UNITED STATES PATENT AND TRADEMARK OFFICE

10/634,967

Office Action Summary

DETAILED ACTION

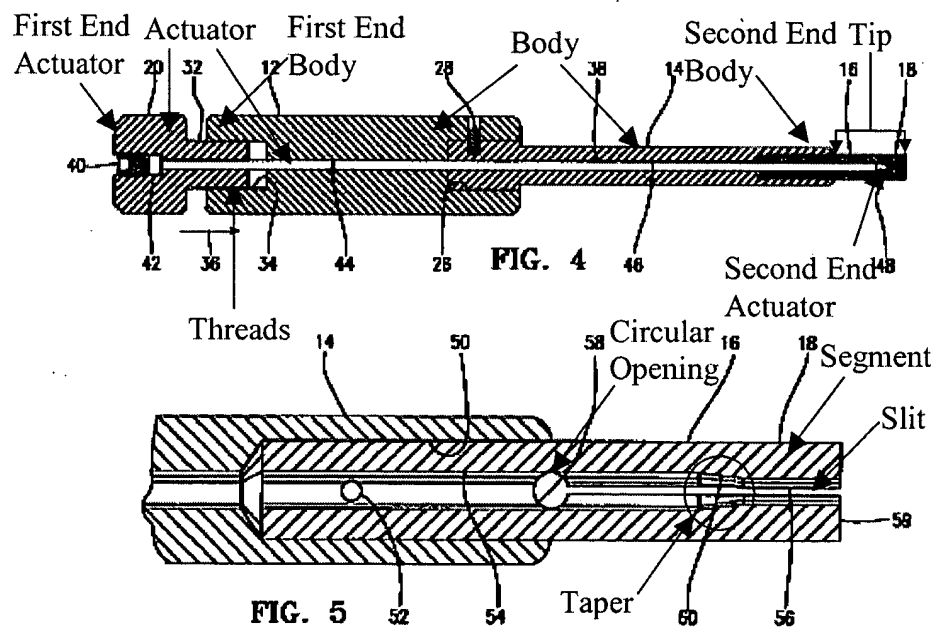
screws (reference figures 4 and 5 below). Regarding claim 1, Hajianpour shows an instrument with a body (12, 14, 16, and 34) that includes a first end, a second, and an axis between. Hajianpour also shows an engagement tip (16) adjacent to the second end that is receivable by the work piece. The tip (16) is divided by a slit (56) that form segments with the ability to extend outwardly and grip a screw or nail. Regarding claim 3, Hajianpour shows an instrument that has a body with a bore (44 and 46) that extends from the first end of the instrument towards the tip of the instrument and continues a predetermined distance past the beginning of the slits (56). Hajianpour also teaches an actuator (20, 32, 38, 40, 42, and 48) having a shaft (38) that is placed into the bore (44 and 46) of the instrument body (reference figure 4 below). The actuator can be translated axial through the body of the instrument between an unlocked position, in which the actuator is not biasing the tip segments, and a locked position, in which the actuator is biasing the tip segments. Regarding claim 4, Hajianpour shows an actuator that uses threads (32) to engage threads (34) within the body of the instrument (column 4 lines 29-31). Turning the actuator causes it to turn axially between the locked and unlocked positions (column 4 lines 32-34). Regarding claims 5-7, Hajianpour shows that body contains a bore (44 and 46) that contains a tapered section with a larger first diameter and a second smaller diameter. The taper is located past the beginning of the slit (56) located in the tip (16) of the instrument. When the actuator is engaged with the taper, the segments of the instrument tip (16) are expanded outwardly (column 5 lines 3-7). Regarding claim 8, Hajianpour shows an actuator with a tapered end (48) that bias the segments of the instruments tip (16) when engaged with the taper in the bore (44

and 46) of the body. Regarding claim 9, Hajianpour shows the bore (44 and 46) extends completely through the body of the instrument. Regarding claim 10, Hajianpour shows that the slits (56) that through the tip (16) of the instrument terminate with a circular opening (58) to reduce stress concentrations (column 4 lines 51-54). Figure 5 shows the radius of the circular opening (58) to be greater than half the width of the slit (56).

FIG. 10

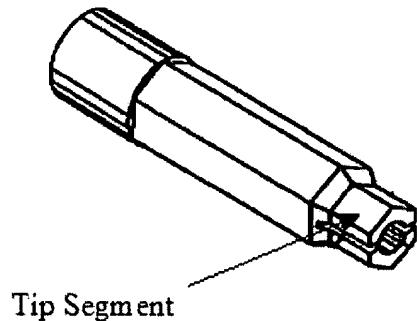
Regarding claim 11, Hajianpour shows an instrument tip (16) that engages a screw or nail in a torque transmitting relationship. Regarding claim 12, Hajianpour shows an instrument tip (16) that has a hexagon shape, reference figure 10 below, which includes flats and vertices to increase the engagement between a screw or nail and the instrument tip (16). Regarding claim 14, Hajianpour disclose that the segments of the instrument tip (16), when biased by the actuator, have at least one vertex that engages the screw or nail. Regarding claim 15 and 16, Hajianpour discloses an instrument that can be used on any screw or pin, including pins or screws used in rotating hinge knee prosthesis, with an internal socket. Regarding claim 20, Hajianpour discloses a device wherein the actuator biases the segments near the segment bases as the actuator is being introduced to the segments. Regarding claim 21, Hajianpour discloses a device wherein the actuator is limited in displacement by the engagement of the second end of the actuator and the first end of the body. With regard the statement of intended use and other functional statements, they do not impose any structural limitations on the claims distinguishable over Hajianpour, which is capable of being used as claimed if one so desires to do so. *In re Casey*, 152 USPQ 235 (CCPA 1967) and *In re Otto*, 136 USPQ 458, 459 (CCPA 1963). Furthermore, the law of anticipation does not require

In response to the applicant's argument that Hajianpour (U.S. 6,286,401) fails to disclose the engagement tip not being slit through the vertices, it is noted in Figure 10 (shown above) Hajianpour discloses an embodiment of the engagement tip wherein the vertices are not intersected by the tip.
